Access Compliance Report

Public Rights-of-Way

(Curb Ramps)

Intersection ID: 46789	Main Street: STOWE_ACRES_DR	Cross Street: WILTON_GATE_DR	Location: SW
ADA ID: 9C747065C935	Ramp Type: Perp	Initial Pass/Fail: Fail	Overall Compliance: No
Severity Score: 12.5			
Codes/Mitigation Info/Possible Solution		Field Measurements/Component Compliance

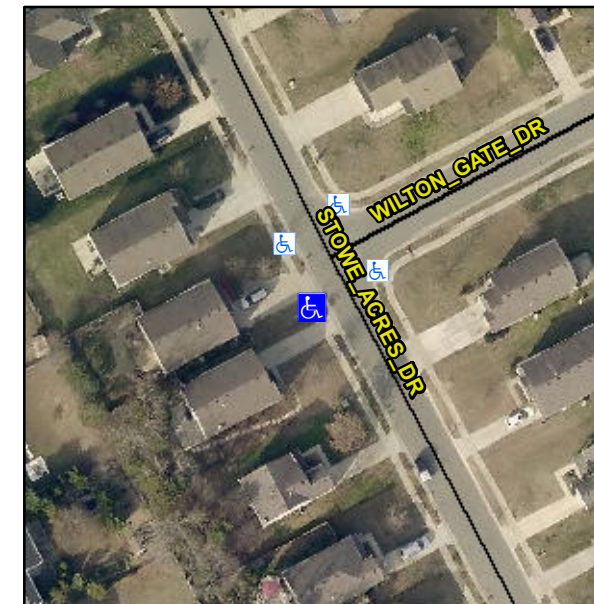
R304.2.2

Compliance	Description	Data	Compliance	Description	Data
N/A	Ramp Length (in)	46.0	No	Ramp Slope (%)	10.5
Yes	Ramp Width (in)	48.5	Yes	Ramp XSlope (%)	0.9
N/A	Flare Type LT	N/A	N/A	Flare Type RT	N/A
N/A	Flare Slope LT (%)	N/A	N/A	Flare Slope RT (%)	N/A
N/A	Flare Traversable LT?	N/A	N/A	Flare Traversable RT?	N/A
N/A	Landing Length (in)	N/A	N/A	DWS Provided?	N/A
N/A	Landing Width (in)	N/A	N/A	DWS Contrast?	N/A
N/A	Landing Slope (%)	N/A	N/A	DWS Length (in)	N/A
N/A	Landing X Slope (%)	N/A	N/A	DWS Full Width?	N/A
N/A	Landing Curb? (Y/N)	N/A	N/A	DWS Offset (in)	N/A
N/A	Shared Landing?	N/A			
N/A	Gutter Ponding?	N/A	N/A	Gutter Slope (%)	N/A
N/A	Gutter Lip Ht (in)	N/A	N/A	Gutter X Slope (%)	N/A
N/A	Painted X Walk1?	No	N/A	Painted X Walk2?	N/A
	X Walk 1 Direction	To E		X Walk 2 Direction	N/A
N/A	X Walk 1 Width (in)	N/A	N/A	X Walk 2 Width (in)	N/A
	X Walk 1 Slope (%)	1.9		X Walk 2 Slope (%)	N/A
	X Walk 1 X Slope (%)	0.5		X Walk 2 X Slope (%)	N/A

Remove & Replace Entire Ramp.
